SERVICE BULLETIN

TO : EC130 Helicopter Owners/Operators
FROM : FDC/aerofilter Engineering
SB NUMBER : SB.FDC.EC130.0006
ORIGINAL SB NO. : SB EC130-002
CATEGORY : Mandatory Service Bulletin
EFFECTIVITY : EC130 equipped with STC SR01373SE
DATE : July 29, 2005

SEAL MODIFICATION KIT INSTALLATION

Figure 1 – D-Seal Groove (Reference)

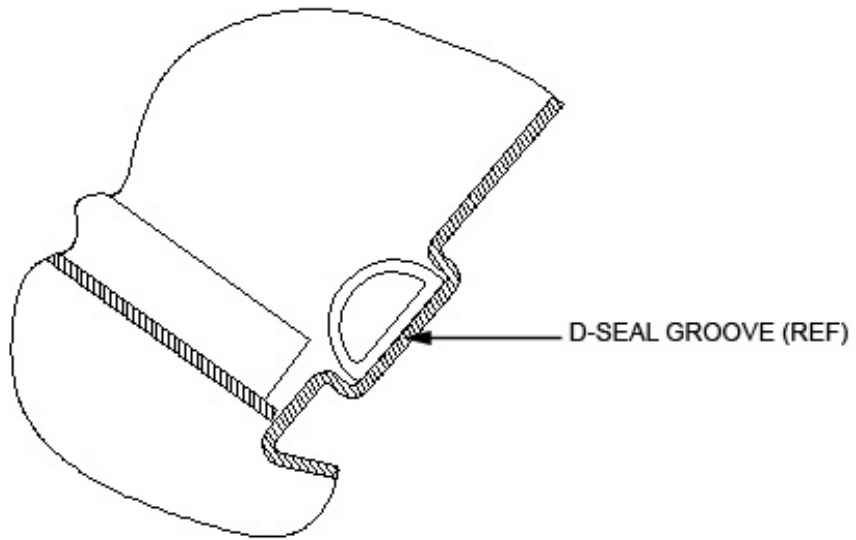
- (7) Clean bonding area surfaces of aft D-seal groove, referenced in Figure 1, with Acetone (Federal Specification number O-A-51G) or Methyl Ethyl Ketone (MEK) (Federal Specification TT-M-261B).

- (8) Scuff bonding area surfaces of aft D-seal groove and shim P/N 1130KP1-1, referenced in Figure 1, with 200 grit aluminum oxide sand paper. Use vacuum or compressed air to remove sanding debris from surfaces.

**Figure 2 – Support P/N 1130KP2-1 Location (Reference)
(View looking aft)**

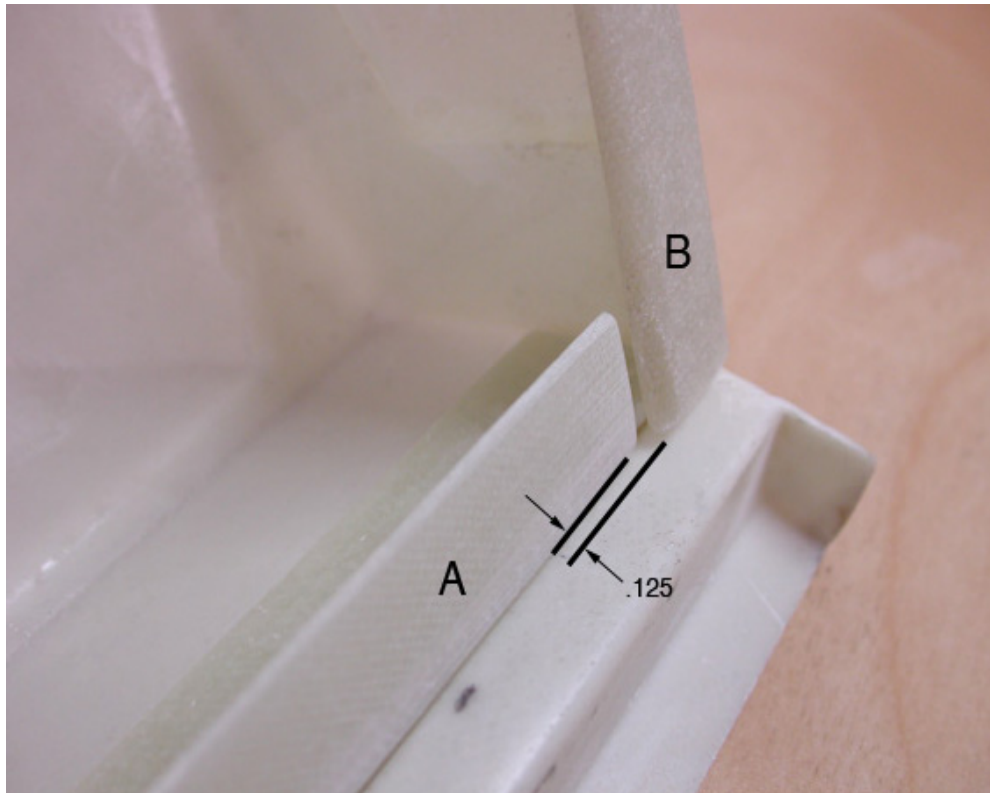
NOTE: Locate support P/N 1130KP2-1, where support P/N 1130KP2-1 surface "A" is .125 inches spaced from upper housing surface "B" before the Hysol adhesive P/N EA 934NA or 3M adhesive P/N DP420 is fully cured in step 14. Refer to figure 2.

Figure 3 – Assembly Reference

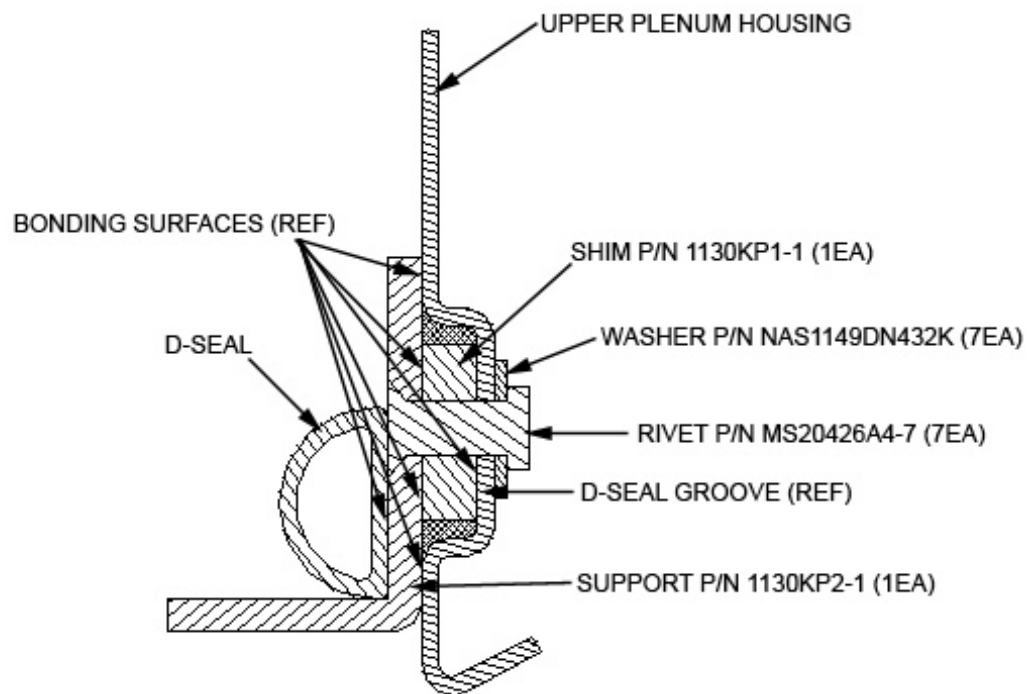
- (9) Bond shim P/N 1130KP1-1, centered to the aft D-seal groove, using Hysol adhesive P/N EA 934NA or 3M adhesive P/N DP420. Refer to Figure 3.
- (10) Allow adhesive to cure to adhesive manufacturer's requirements.

- (11) Locate holes from shim P/N 1130KP1-1 and transfer drill (DIA. 0.128) thru upper housing (7 places).
- (12) Clean bonding area surfaces of SHIM P/N 1130KP1-1, support P/N 1130KP2-1 and applicable area of upper housing, with Acetone (Federal Specification number O-A-51G) or Methyl Ethyl Ketone (MEK) (Federal Specification TTM-261B). Refer to Figure 3.

- (13) Scuff bonding area surfaces of shim P/N 1130KP1-1, support P/N 1130KP2-1 and applicable area of upper housing, with 200 grit aluminum oxide sand paper. Use vacuum or compressed air to remove sanding debris from surface. Refer to Figure 3.

1130KP2-1, shim P/N 1130KP1-1 and upper plenum housing.
Refer to Figure 3.

- (18) Clean bonding area surfaces of support P/N 1130KP2-1 and D-seal with Acetone (Federal Specification number O-A-51G) or Methyl Ethyl Ketone (MEK) (Federal Specification TT-M-261B). Refer to Figure 3.

- (19) Scuff bonding area surfaces of support P/N 1130KP2-1, with 200 grit aluminum oxide sand paper. Use vacuum or compressed air to remove sanding debris from surface. Refer to Figure 3.

- (20) Apply Pro-Seal P/N PR1440-B2 (AMS-S-8802) or High Temperature RTV General Electric product adhesive P/N 103, 108 (MIL-A-46106) or Dow Corning P/N 832 Multi-Surface Adhesive Sealant to prepared support P/N 1130KP2-1 surface and D-seal. Refer to Figure 3 for D-seal location.

- (21) Bond D-seal to support P/N 1130KP2-1 taking care to ensure a positive mating of the D-seal to support P/N 1130KP2-1 is accomplished. Refer to Figure 3 for D-seal location.
